Discussion Paper on Public Open Space in the Chatswood CBD Precinct

Figure 6.2.7 Recommended links and new open space

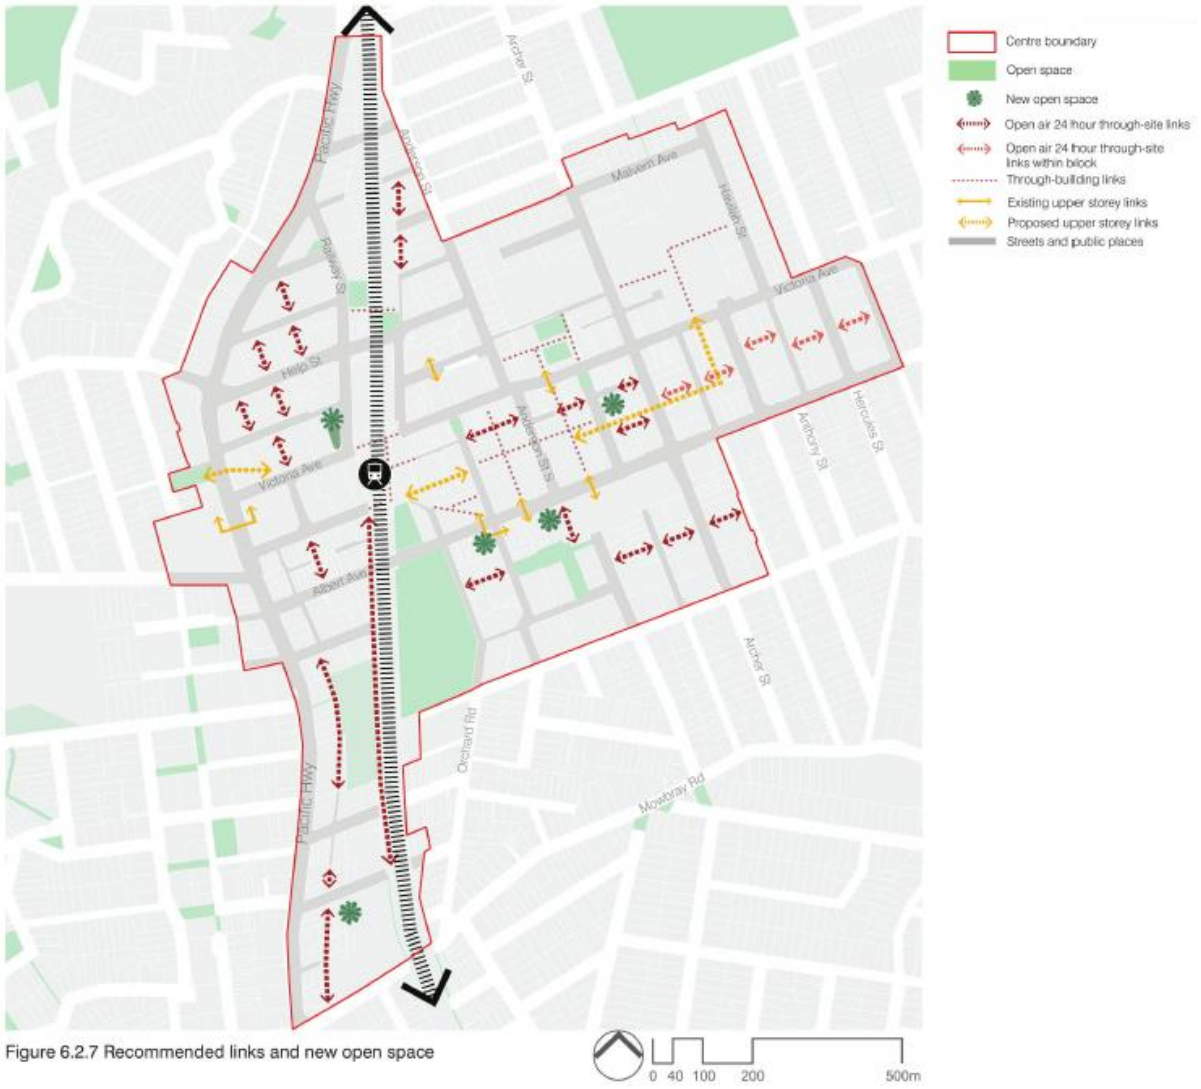
- 5) What links should the community be advocating for that are covered in Figure 6.2.7 of the Draft Architectus CBD Strategy?
- 6) Figure 6.2.7 suggests 3 new open spaces east of the railway corridor. One on the site of the current youth centre, in the current car park site opposite Anderson Street on Albert Avenue and the other on corner of Spring Place and Spring Street.

- 7) Instead of the open space in the current car park site opposite Anderson Street on Albert Avenue and a 24 hour through link from Currey Park through to Archer Street, should we advocate for a 20-25 meter wide through site park (i.e. similar to Currey park, path and grass and garden on edges with seats to sit) between the redeveloped car park and the Quest development on the corner of Albert Avenue and Archer Street? The Park would be basically north south facing, nearly line up with Spring Street, thus during the middle of the day in 50 years time, there might just be minimal overshadowing of this park through link.

- 8) Concern is that the proposed open spaces in Albert Avenue in 20, 30, 40 years' time will be significantly overshadowed during the hours of 10am and 3pm as they are directly south of B3 commercial zone land with a height restriction of 246.8 meters
